UNITED STATES
DEPARTMENT OF THE INTERIOR
BUREAU OF LAND MANAGEMENT

SUNDRY NOTICES AND REPORTS ON WELLS
Do not use this form for proposals to drill or to re-enter an abandoned well. Use form 3160-3 (APD) for such proposals.

DEVON ENERGY PRODUCTION COMPANY, L.P. respectfully requests approval to abandon Strawn perms and recomplete up hole to 3BSSS as follows:

Burton Flat Deep Unit 41
30-015-27800
Devon Energy Production Co., LP
January 19, 2016
Conditions of Approval

DEVON ENERGY PRODUCTION COMPANY LP

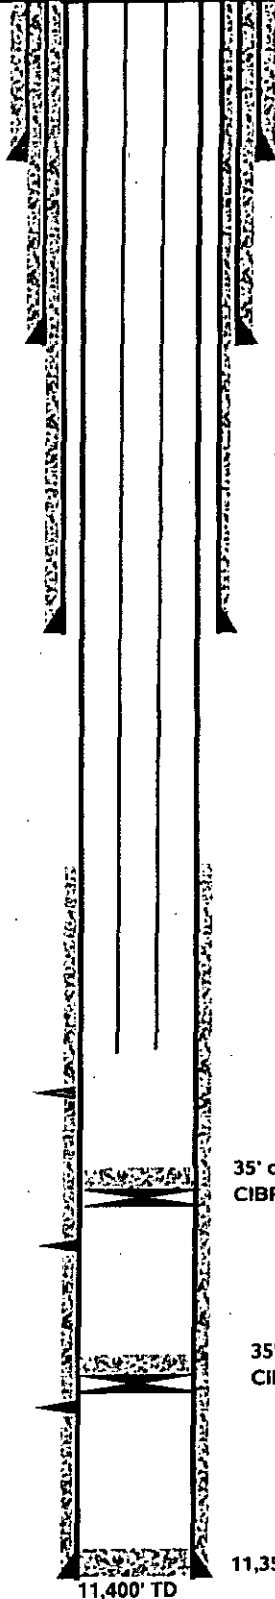
- 1. Operator shall TAG CIBP and cement at 10,515'.**
- 2. Operator shall place CIBP at 10,100 and place 35' of Class H cement on top as proposed. WOC and tag.**

- 3. Must conduct a casing integrity test before perforating and fracturing. Submit results to BLM. The CIT is to be performed on the production casing to max treating pressure. Notify BLM if test fails**
